DEVELOPMENT REVIEW BOARD  
SUPPLEMENTAL SUBMITTAL

PROJECT NO. PR-2019-002765

Application No. SD-2020-00218 / VA-2021-00010

**Re: Proposed Lots 8-A, 8-B, 8-C, 9-A, 9-B and 9-C, Coors Pavilion**

# 210202 - Water

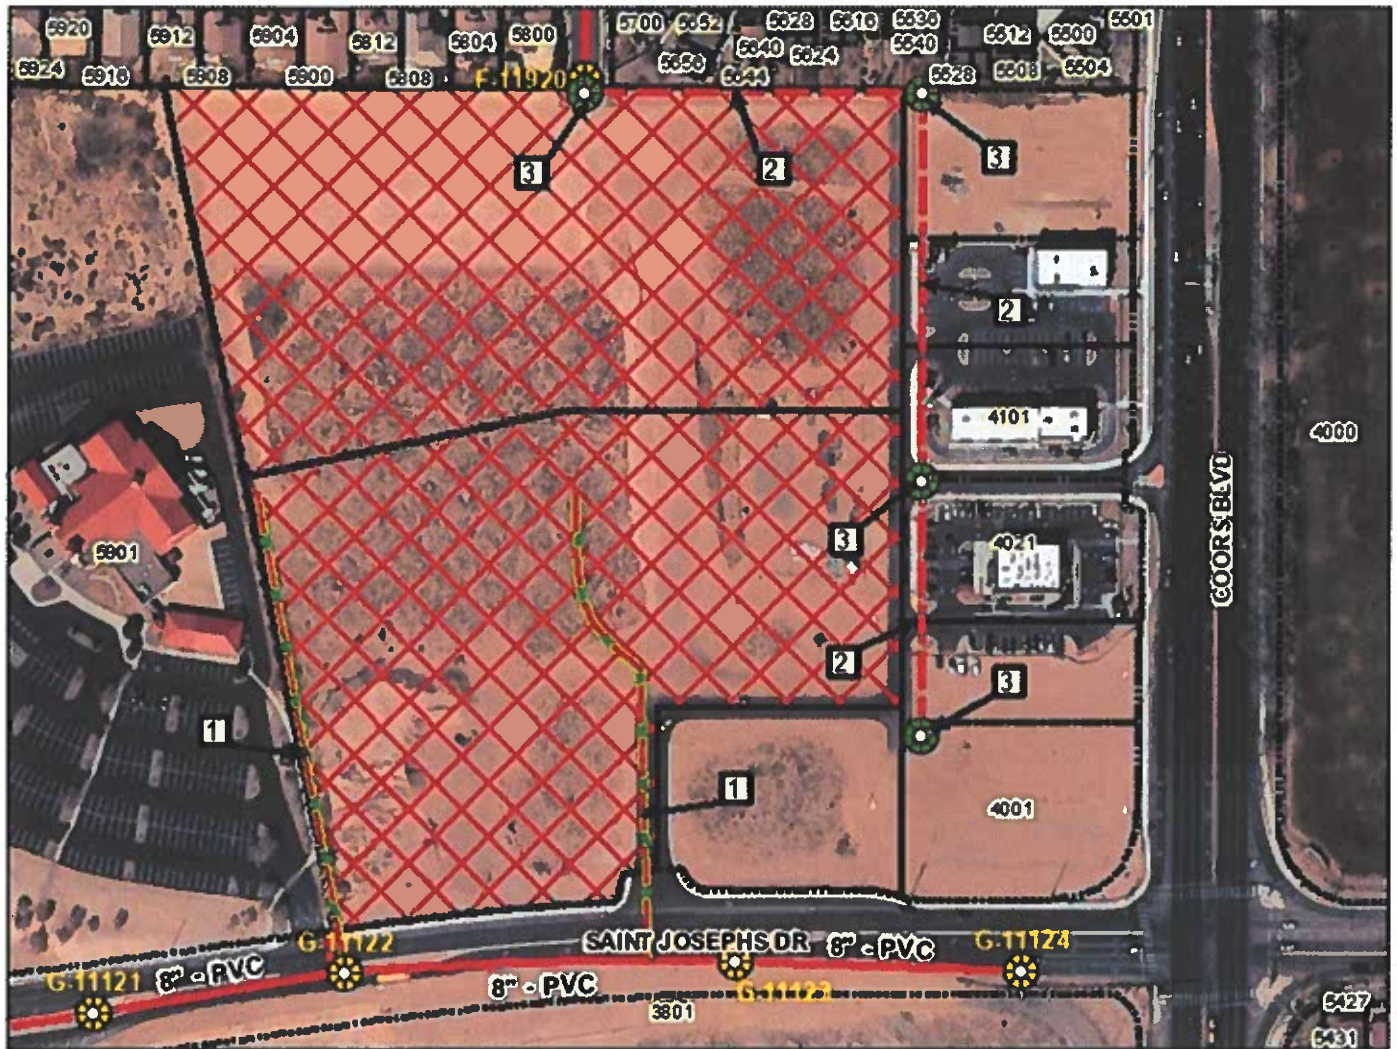
**Water Service:** New metered water service to the properties can be provided contingent upon a developer funded project. The current existing infrastructure can serve lots 9-A, 9-B, 9-C, and 8-B. A public, ten-inch PVC water line exists west of lot 8-C and 8-A. If the line and public water easement is sufficiently long enough to serve lots 8-A and 8-C, this line may be used for metered potable service. The eight-inch waterline inside the Coors Pavilion site shall be extended along northern frontage of lot 8-B, eastern frontage of 8-A, the eastern frontage of 8-C and tied into the eight-inch PVC main along St Josephs to create a looped system serving Lots 8-1 and 8-C. If an easement is granted this extension may also be looped along the northern frontage of lot 7 and tied into the eight-inch PVC line inside Coors Pavilion.

# 210202 - Sanitary Sewer

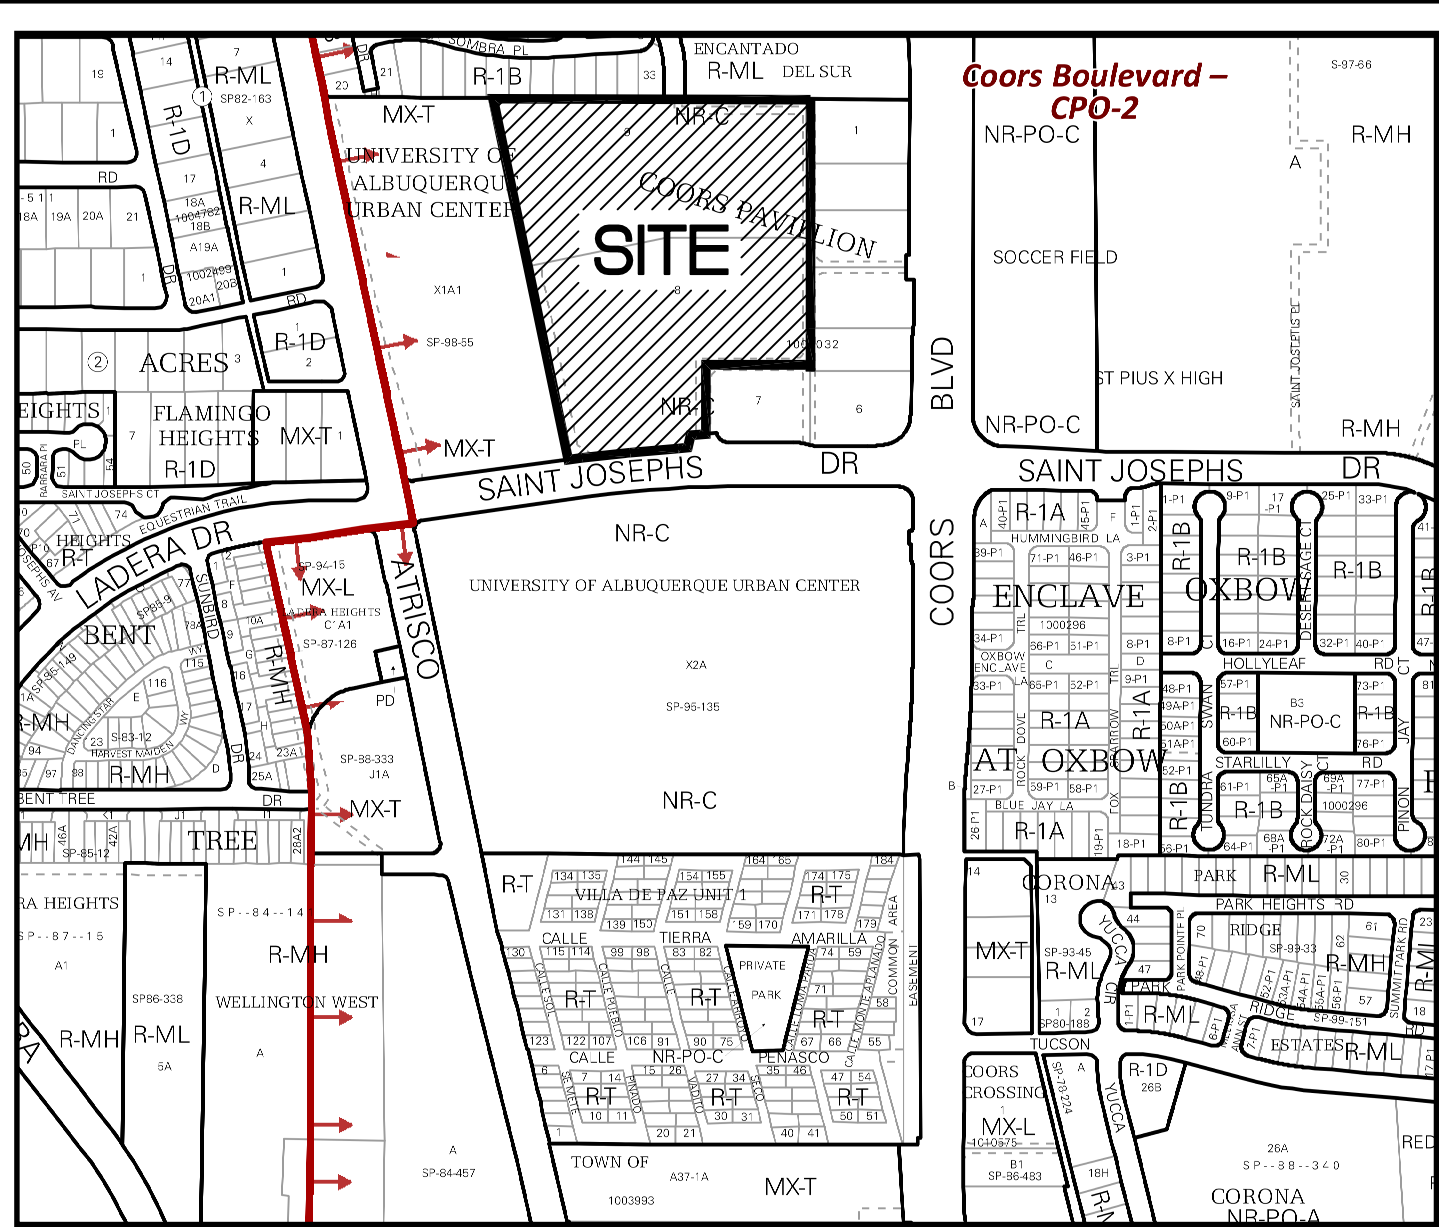
**Sanitary Sewer Service:** Sanitary sewer service can be provided contingent upon a developer funded project. The existing onsite sanitary sewer line is private, but will be transferred to the Water Authority and this section is written with the assumption that it will be a public line. The current existing infrastructure can serve lots 9-A, 9-B, 9-C, and 8-B. A sewer line would need to be constructed along the eastern frontage of lots of 8-A & 8-C and connected to the eight-inch PVC collector line along Saint Josephs Dr. The sewer line could be extended into the frontage of lot of 9-A if desired. A second option exists which would be contingent upon obtaining a public sanitary sewer easement along the western frontage of lots 8-A and 8-C and constructing a sewer line along this easement, connecting to the eight-inch PVC collector line along Saint Joseph's Dr. Further options may be feasible but were not depicted as public sewer easements on the plat documentation included for review.

**Detail of Easements 1, 4, 8, 9, 10, 13, 16, 19, 21, and 22**

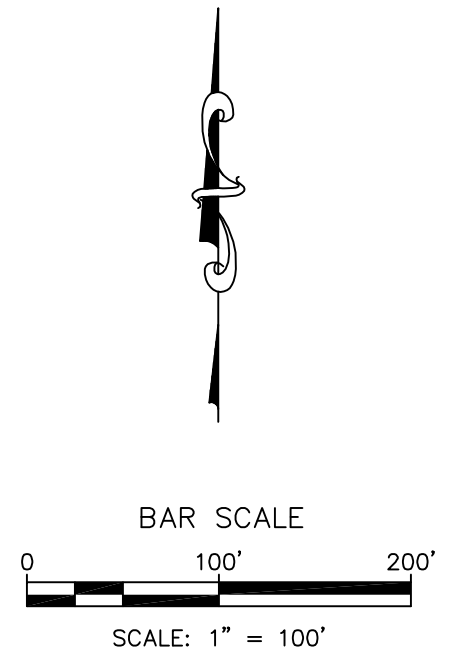
- j. If Easement #13 is to be for a public waterline and sanitary sewer, there will need to be additional offsite public sanitary sewer for this easement to connect to the public sanitary sewer that will be granted for the converted public sanitary sewer. There is a gap between the east property line of proposed Lot 9-C and the public sanitary sewer easement associated with the converted public sanitary sewer.
  - i. Response to comments referred to Detail B on Sheet 2. This detail shows easement #13 as the same width of easement #16. The dimension shows easement #13 having a width of 30', whereas the keyed note for easement #16 indicates a width of 20'. Please confirm.

Labels have been added to the detail on Sheet 2, which confirms the easement 16 matches the easement 13 width of 30 foot as labeled, where it serves to bridge easement 16 to 13. The easement not indicating easement 16 is 20 feet has been removed to avoid this confusion.
